Statement of Basis for Draft Title V Operating Permit No.
V-UO-000004-00.00 (Apr. 28, 2014)

**Air Pollution Control
Title V Permit to Operate
Draft Permit No. V-UO-000004-00.00
Draft Initial Part 71 Permit**

**Deseret Power Electric Cooperative
Bonanza Power Plant
Uintah and Ouray Reservation
Uintah County, Utah**

Statement of Basis

Figure 1.⁴²

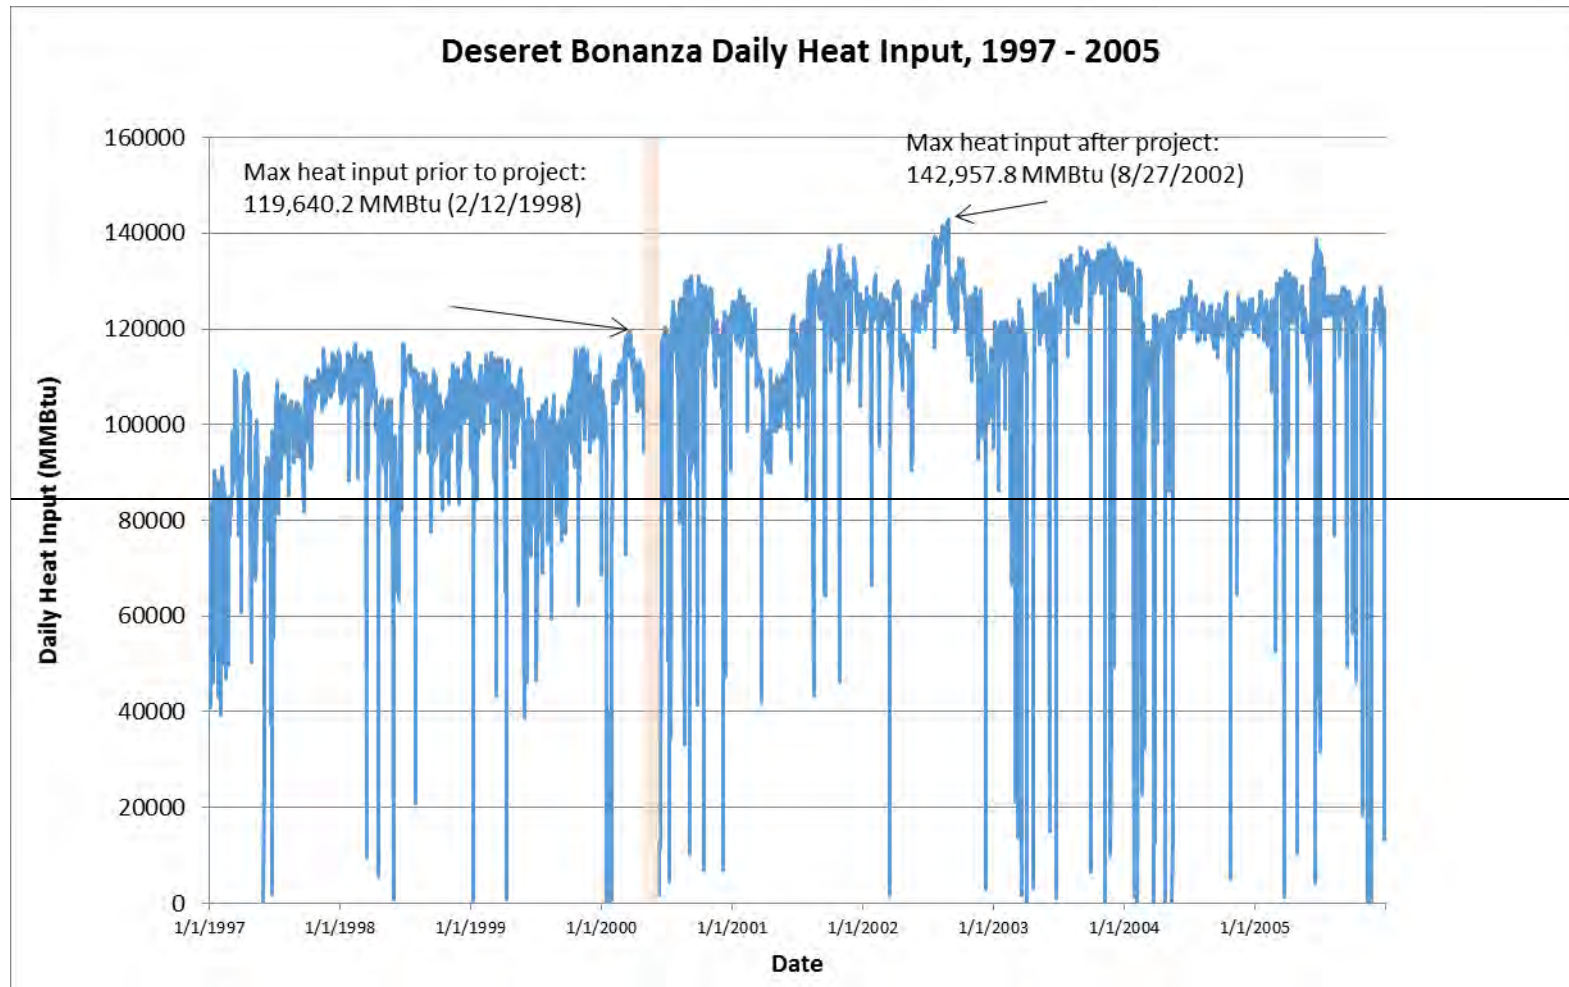
EPA has examined daily actual heat input data on the Bonanza power plant from 1997 through 2005, in an attempt to evaluate the extent to which an increase in actual heat input capacity may have occurred and been utilized as a result of the ruggedized rotor project.³² Results are presented in Figure 1, at page 52 below. For example, if one compares the pre-project daily actual heat input values with post-project daily actual heat input values, then it appears that actual post-project heat input has, in fact, been in excess of the plant's pre-project capacity.³³ Prior to the project, the maximum actual daily heat input was 116,940 MMBtu, while after the project the maximum actual daily heat input was 142,958 MMBtu. Moreover, following the project, the actual daily heat input exceeded the pre-project maximum of 116,940 MMBtu on most days. When considered

³³ Daily heat input data obtained from the Air Markets Program Data and based on the procedures found in 40 CFR Part 75, Appendix F. Refer to Figure 1 of this document.
